# City of Alachua

## Planning & Community Development Department Staff Report

August 11, 2020

<b>SUBJECT:</b>	A request for a Site Plan to construct a ±3,349 square foot quick service restaurant with associated parking, stormwater, landscaping, and site improvements
<b>APPLICANT/AGENT:</b>	Robin Kendall, Quality Dining, Inc.
<b>PROPERTY OWNER:</b>	T&H Property Group, LLC
<b>LOCATION:</b>	16130 NW US Highway 441
<b>PARCEL ID NUMBERS:</b>	03061-004-001
<b>FLUM DESIGNATION:</b>	Commercial
<b>ZONING:</b>	Commercial Intensive (CI)
<b>OVERLAY:</b>	US 441/I-75 Gateway Overlay District
<b>ACREAGE:</b>	±1.19 acres
<b>PROJECT PLANNER:</b>	Justin Tabor, AICP
<b>RECOMMENDATION:</b>	Staff recommends that the Planning & Zoning Board approve the Site Plan for quick service restaurant at 16130 NW US Highway 441, subject to the three (3) conditions provided in Exhibit "A" and located on page 21 of the August 11, 2020 Staff Report to the Planning & Zoning Board.
<b>RECOMMENDED MOTION:</b>	<i>Based upon the competent substantial evidence presented at this hearing, the presentation before this Board, and Staff's recommendation, this Board finds the application to be consistent with the City of Alac

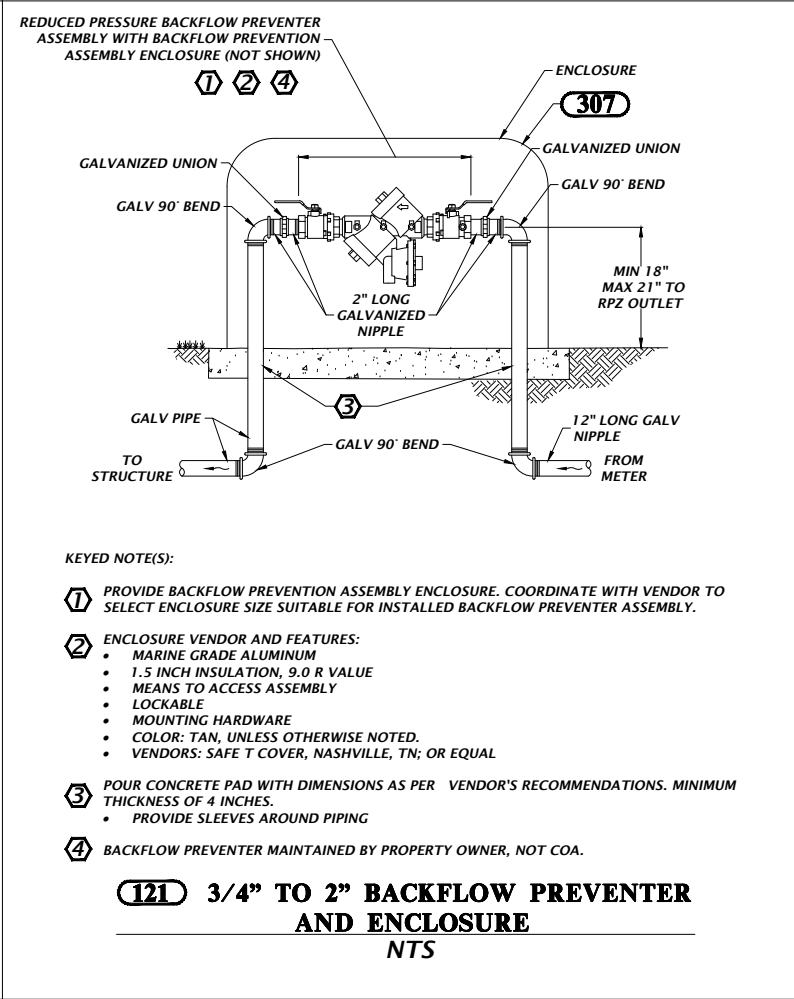
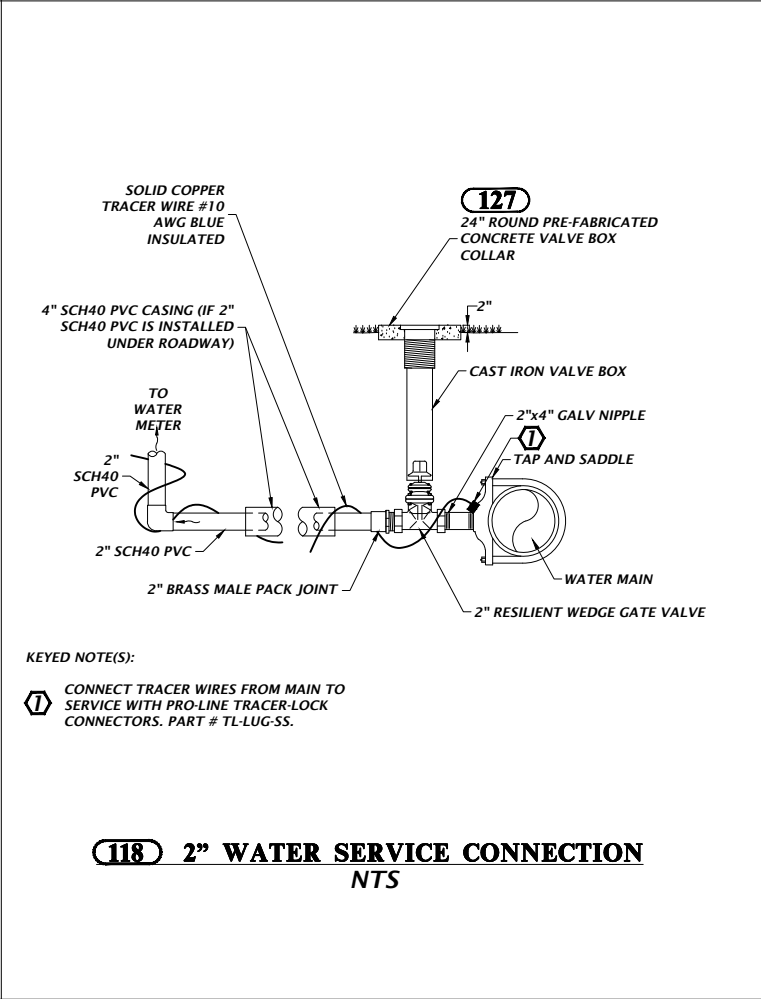
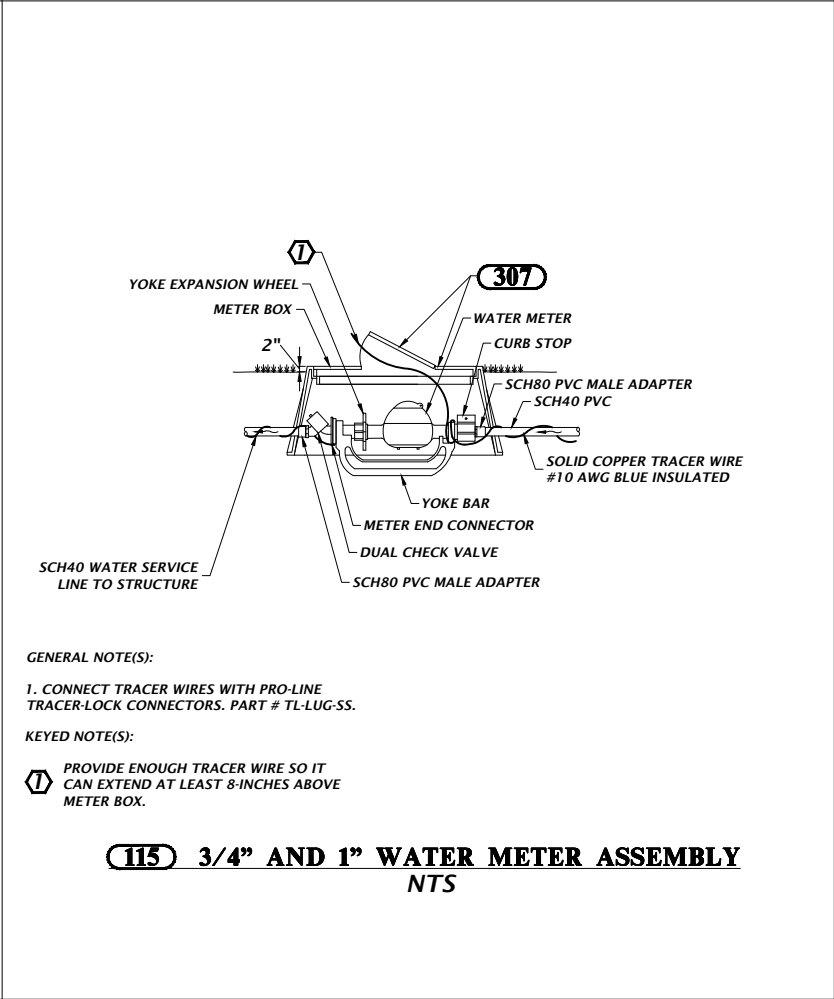
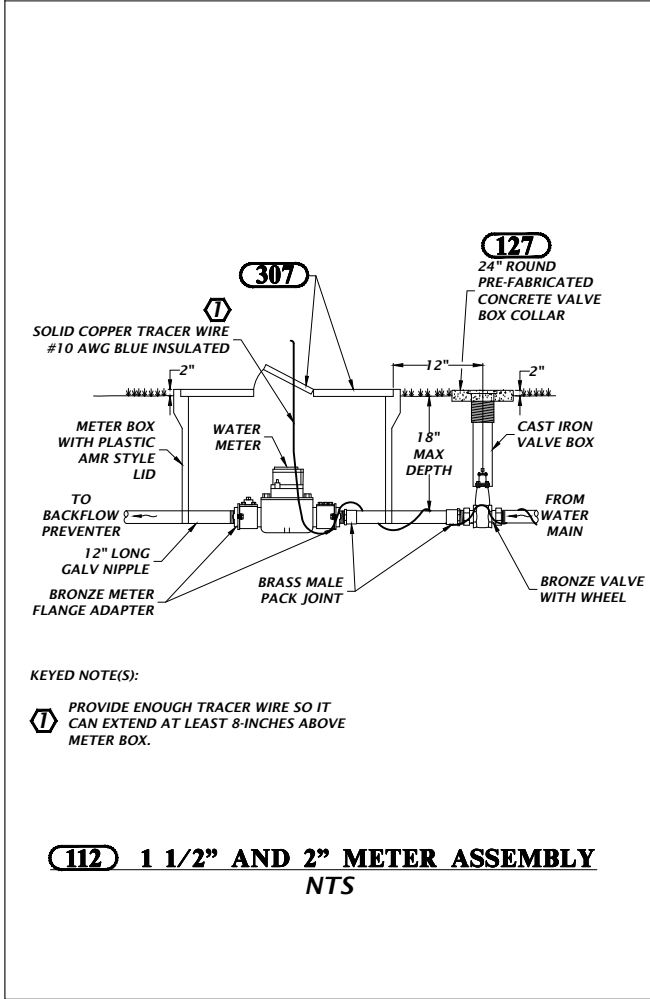
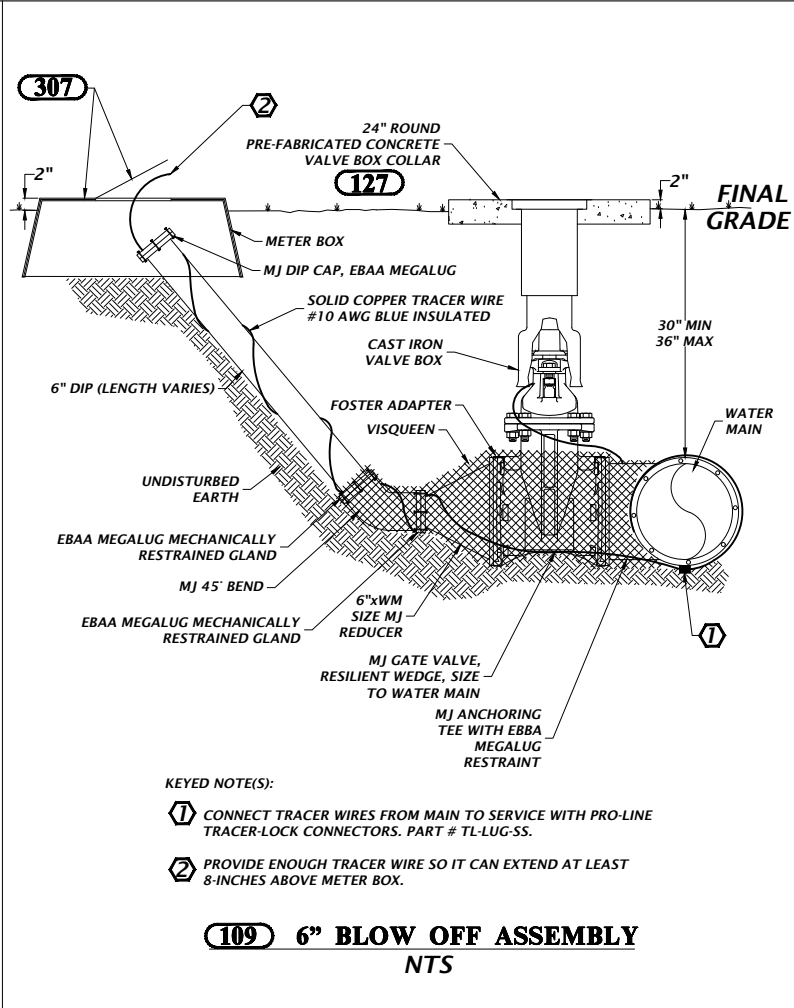
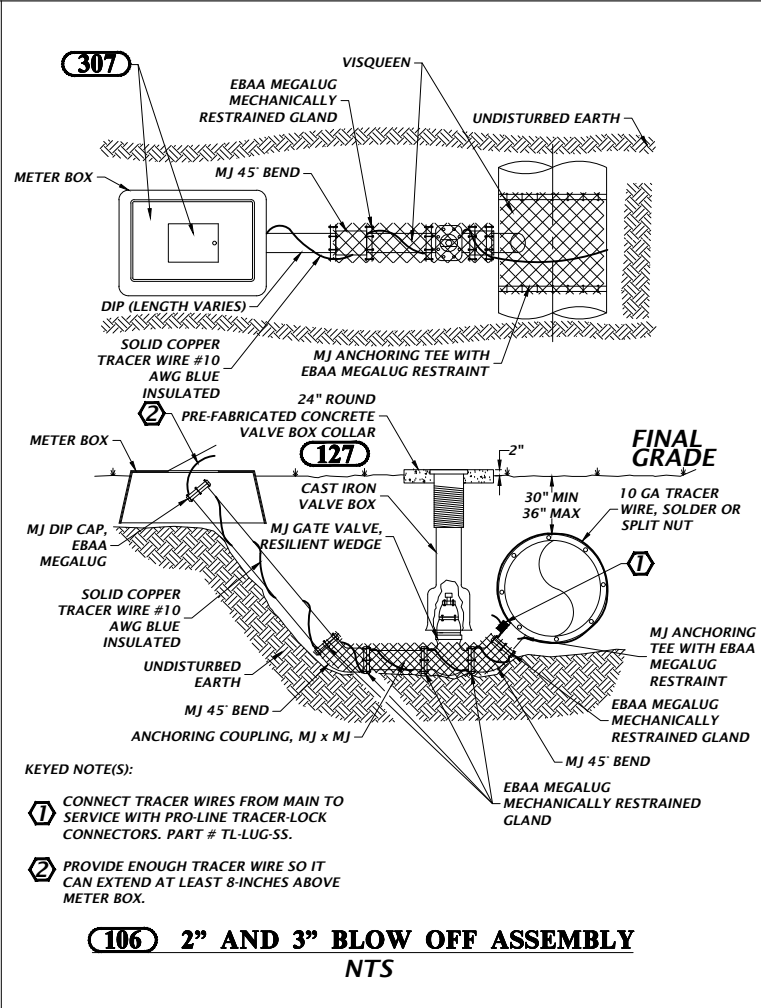
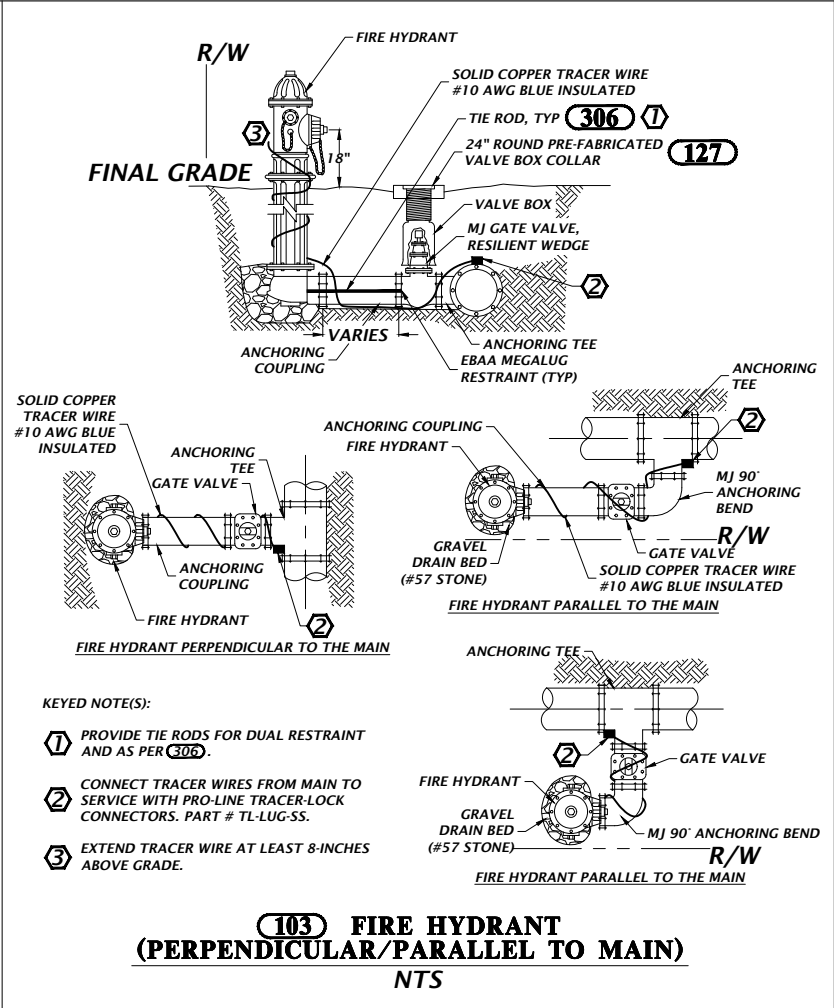
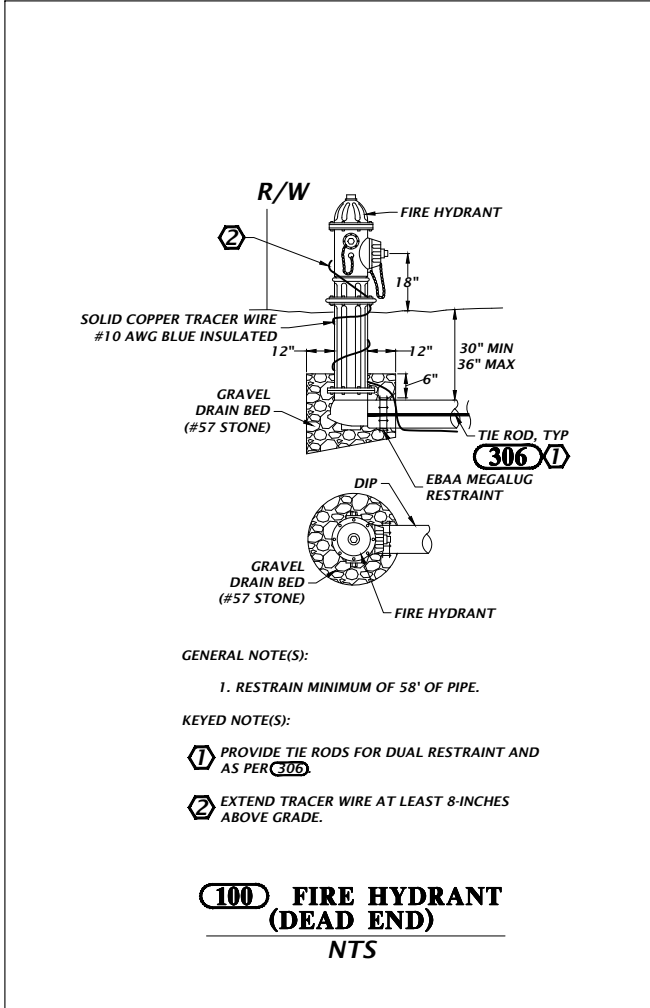
NO.	COMMENTS
1.	<p><b>Comment on Jan 12th Submittal</b></p> <p><b>Sheet C02:</b></p> <p>Minor Comment, Referenced Specifications: Please change Note 4 to "City of Alachua, Department of Public Services, Design and Construction Manual, Public Utilities, 2020".</p> <p>Minor Comment, General Note 11: Please replace "City of Alachua Water &amp; Sewer District" with "City of Alachua Public Services Department".</p> <p>Please add the following note: "XX. Electric service provided by the City of Alachua".</p>

2.	<p><b>Comment on Jan 12th Submittal</b></p> <p><b>Sheet C04:</b></p> <ul style="list-style-type: none"> <li>On the lower right of property is a fenced (8-foot high PVC fence) area. What is its purpose? Other than the gate facing the road, does it need another gate so it can be accessed from the Burger King building?</li> <li>The gate is shown as the "swing-out" type. Please change to a "swing-in" type so it</li> </ul>

NO.	COMMENTS
	reduces staff-traffic interface.
3.	<p><b>Comment on Jan 12th Submittal</b></p> <p><b>Sheet C05A:</b> To enhance clarity, suggest changing the pavement legend text to:</p> <ul style="list-style-type: none"> <li>• “Standard Duty Asphalt (See U.S. 441 Driveway Pavement Detail)”</li> <li>• “U.S. 441 Shoulder Asphalt (See Shoulder Pavement Detail)”</li> </ul>

4.	<p><b>Comment on Jan 12th Submittal</b></p> <ul style="list-style-type: none"> <li>• Sheet C06, Note 4: Please review meaning of “conveyed”? Should it instead be “connected”?</li> <li>• Sheet C06, General Utility Note 9: Please add “electric service”.</li> <li>• Sheet C06, Please add the following general note: “In the right-of-way, to both the 2-inch water line and 6-inch gravity sewer main, install 2-pair, 10- gauge tracer wire with enough unwrapped wire to allow connection to test device.”</li> </ul>

5.	<p><b>Comment on Jan 12th Submittal</b></p> <ul style="list-style-type: none"> <li>• Sheet C06, Electrical: The electric service will not be provided from the overhead line and power pole. Instead show a pad-mounted transformer close to where the power pole is. Also, show a new underground electric line from the Utility Box to the pad-mounted transformer.</li> <li>• Sheet C05, Electrical: Please add the following General Utility Note: “The City of Alachua will procure and install the pad- mounted transformer, the pad and also the conduit &amp; conductors from the utility box to the pad-mounted transformer. This work shall be done at no cost to the City, who will backcharge the Contractor. All electric work “downstream” the transformer shall be the responsibility of the Contractor”.</li> </ul>

6.	<p><b>Comment on Jan 12th Submittal</b></p> <ul style="list-style-type: none"> <li>• Sheet C06, Electrical, The City of Alachua will provide 277/460 Volt 3-phase electrical power at the transformer. Please confirm that this is acceptable. Other power types may be available.</li> <li>• Sheet C06: Please provide a load schedule so that the City can size the transformer. When will the load schedule be available?</li> </ul>

7.	<p><b>Comment on Jan 12th Submittal</b></p> <ul style="list-style-type: none"> <li>• <b>Sheet C06, Cleanout:</b> A cleanout is shown within the property line in the lower left. Please either:</li> <li>• Relocate the cleanout so it is in the right-of-way, or:</li> <li>• Keep as is, but add a second cleanout in the right of way, or.</li> <li>• Keep as is, but grant an easement to access the cleanout.</li> </ul>

NO.	COMMENTS
8.	<p><b>Comment on Jan 12th Submittal</b></p> <ul style="list-style-type: none"> <li>Sheet C06: Where the new 2-inch water line connects to the existing 16-inch DIP, a corporation stop is called out. As per CoA standards, please replace with a 2-inch resilient seat gate valve with valve box.</li> </ul>

9.	<p><b>Comment on Jan 12th Submittal</b></p> <ul style="list-style-type: none"> <li>Sheet C06: A dashed line is shown about 10 feet within the property line. What does it represent? Please show on legend sheet.</li> </ul>

10.	<p><b>Comment on Jan 12th Submittal</b></p> <ul style="list-style-type: none"> <li>Sheet C06: Minor Comment: A rectangular symbol has been called out as a "Power Transformer". This is on the lower left near the "OHW" &amp; "PP". This is actually a "SWITCHGEAR". Please change text.</li> </ul>

11.	<p><b>Comment on Jan 12th Submittal</b></p> <p><b>Sheet C06:</b> There is an existing underground electric line (UEL) that is not shown on any of the submitted drawings. Please address the following issues:</p> <ul style="list-style-type: none"> <li>Attached is Figure 1, which is a GIS output. Black is the property line. Red is an overhead electric line that has either has already been demolished or will soon be demolished. The dashed blue line shows an existing UEL, portions of which either coincide with or are very close to the west property line.</li> <li>Please verify that construction of the stormwater basin does not interfere with the UEL. The basin outline is at 80 ft. EL and is east of the UEL. But there appears to be some earthwork required west of the basin that may impact the underground electric line. Note that the underground electric line must have at least 4-feet of cover.</li> <li>There is a C-Inlet near the NW corner of the stormwater basin. If this C-Inlet impacts the UEL, please relocate.</li> <li>Landscaping sheet L-1 shows that trees will be planted near the property line (and buried underground electric line). The distance between trees and the property line/underground electric line appears to be about 7-8 ft., which coincidentally follows the old City standard of 7.5 ft. separation from underground electric utilities. The City is not insisting that the new standard of 15-feet separation be followed. However, could these trees be moved several feet to the east? Also, please verify that these trees (wax myrtle and red maple) have shallow roots.</li> <li>Based upon a preliminary review, there does not currently appear to be an easement for this UEL. Please obtain an public utility easement (PUE). The CoA notes that both the Burger King property and the parcel west of the Burger King property are owned by the same entity; namely, T&amp;H Property Group. Could the PUE be obtained for the UEL for both parcels?</li> <li>CoA suggests that this UEL be shown on the drawings. Suggested approach is to</li> </ul>

NO.	COMMENTS
	request a 811 Line Locator design ticket, which will prompt CoA staff to locate the UEL with visible marking paint and flags at grade. The developer would then instruct the surveyor to update the applicable drawings.

12.	<p><b>Comment on Jan 12th Submittal</b></p> <p>Sheet C09 shows Civil Details, which are based on CoA Standard Details, 2017 Version. Please replace with the updated 2020 standard details, as follows:</p> <ul style="list-style-type: none"> <li>Partly because the updated 2020 standard details cross-reference other sheets, the required number of details has increased from 4 to 6. These 6 detail sheets are attached in PDF format.</li> <li>All CoA standard details are also attached in AutoCad format, version 2014. The Engineer may prefer to use details in AutoCad, which could edited so just the details required for the project would become part of the Contract Documents.</li> </ul>
END OF COMMENTS
